ENGINE – ATTACHING PARTS AND FITTINGS – HP SYSTEM MODULE – IMPROVED COOLING AIR
DEFLECTOR FOR CABIN AIR PRESSURE REGULATING VALVE – CATEGORY CODE 6 – MOD.ENG-72-0191

V2500-ENG-72-0191

Location of cooling air deflector bracket
Fig.1

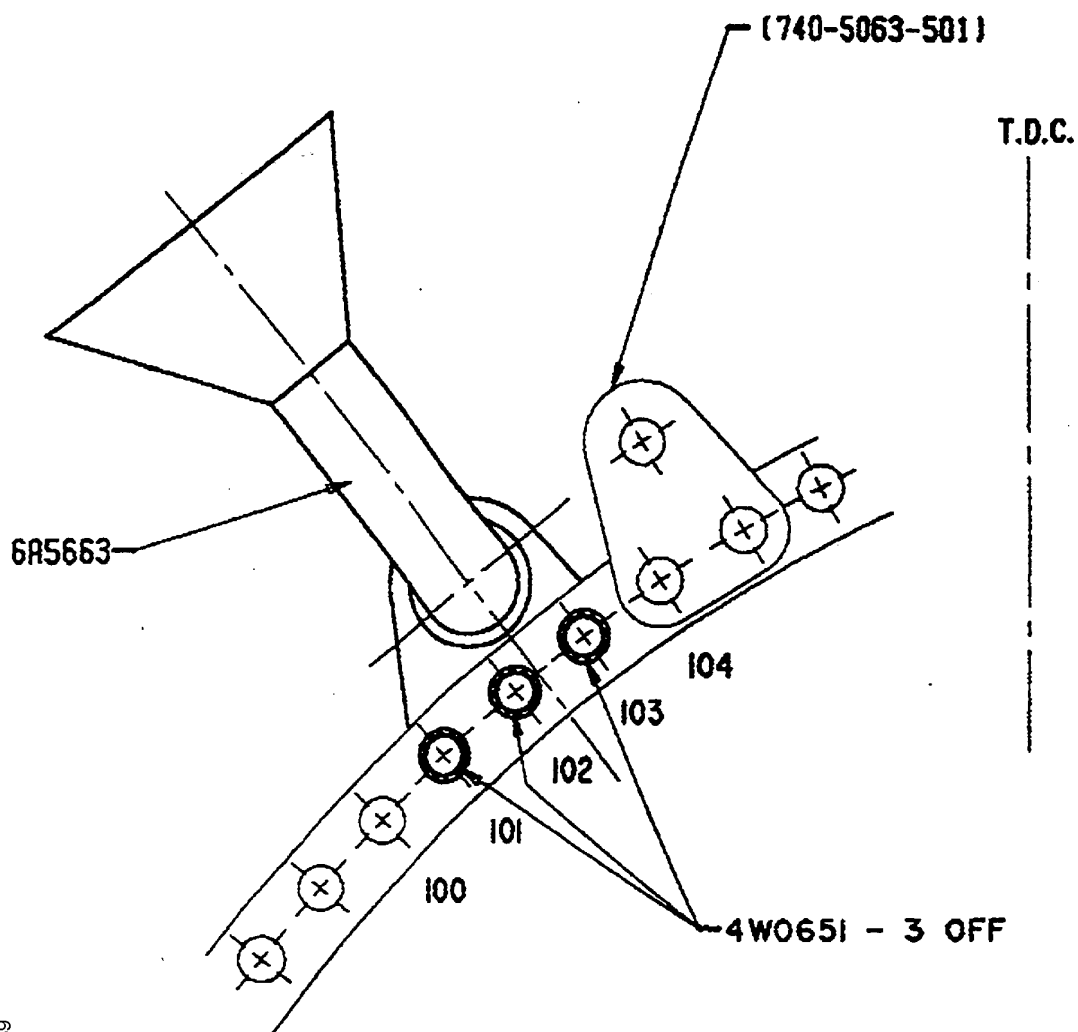
The position of the cooling air deflector bracket relative to the cabin air pressure regulating valve (PRV) has resulted in the flow of cooling air to the valve being reduced.

- (a) The existing deflector bracket assembly is deleted from the front face of flange FK along with the three securing bolts.
- (b) The new deflector bracket assembly is introduced, mounted on the No.19 burner pad utilising the front 2 bolts.
- (c) An additional support bracket is also introduced. The bracket is bolted to the rear face of flange FK using three standard bolts and is also bolted to the new deflector bracket.

- (1) Find 6A5663 bracket. Refer to Figures 1 and 2.
- (2) Remove the 4W0651 bolts (3 off) and 4W0003 (3 off) retaining the 6A5663 bracket. Remove the 6A5663 bracket. Refer to Figure 2.
- (3) Remove the retaining bolt at flange 'FK' hole position 100. Refer to Figure 2.
- (4) Remove the MS9573-13 bolts (2 off) from the diffuser casing (boss 19) fuel nozzle boss. Refer to Figure 3.

View on support bracket (6A5884) showing reworking required
Fig.6

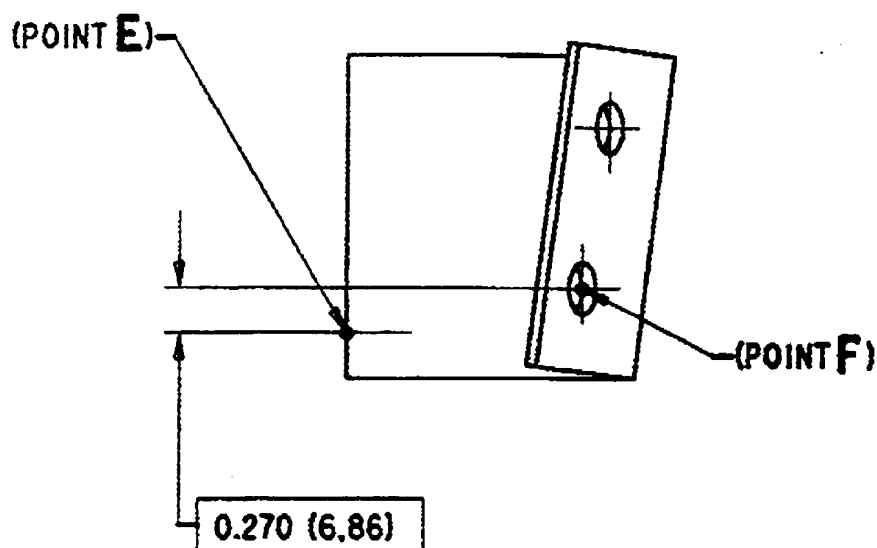
Several engines were delivered to operators with incorrect support bracket clearance holes.

- (b) These support brackets are reworked to incorporate the correct size clearance holes.

Procedure	Supplementary Information	
(a) Install the support bracket on to the machine table	Refer to Figures 6,7 and 8. Align the axis of the three existing bolt holes correctly to the table surface. Use jig boring machine with standard workshop equipment.	
(b) Increase the diameter of the three existing holes	Refer to Figure 8. Use a standard 0.348 in. (8,839 mm) diameter letter 'S' drill.	
(c) Remove sharp edges	Use standard workshop equipment.	
(d) Cancel the old part number and identify with the new part number	Old Part No. 6A5884	New Part No. 6A5899
	Refer to SPM TASK 70-09-00-400-501, SUBTASK 70-09-00-400-001. Use vibro-engraving equipment.
